Office Action Summary

10/724,431

DETAILED ACTION

FIG. 3**Claim Rejections - 35 USC § 103**

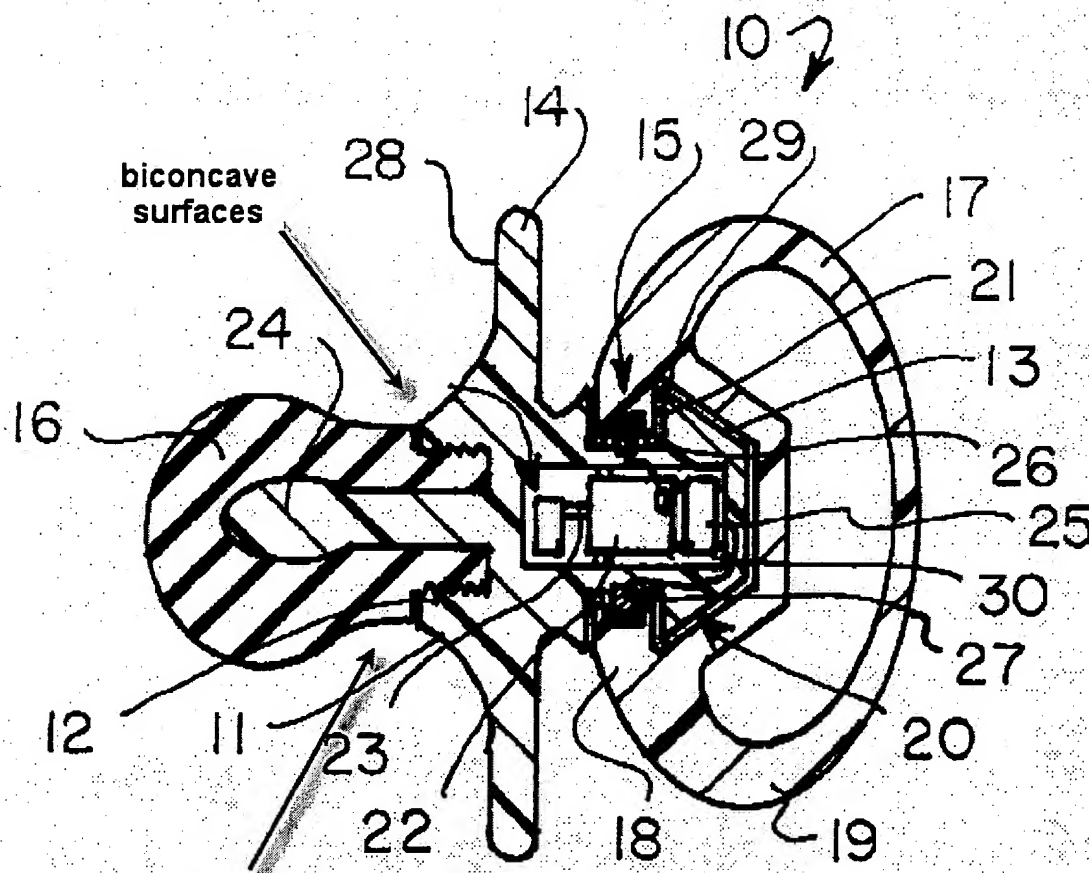
3. Claim 1 is rejected under 35 U.S.C. 102(b) as being anticipated by Landers (US 6,264,678). Landers discloses a vibrating pacifier with a circular holder, a battery operated motor with a vibrating end 24, a shield 14, and a mouthpiece. The motor is contained within a body (col. 3, lines 57-58). Figure 3 shows the nipple member to be biconcave, so to provide increased comfort to a child's mouth (col. 2, line 55) and increasing the surface contact with the child's gum line.
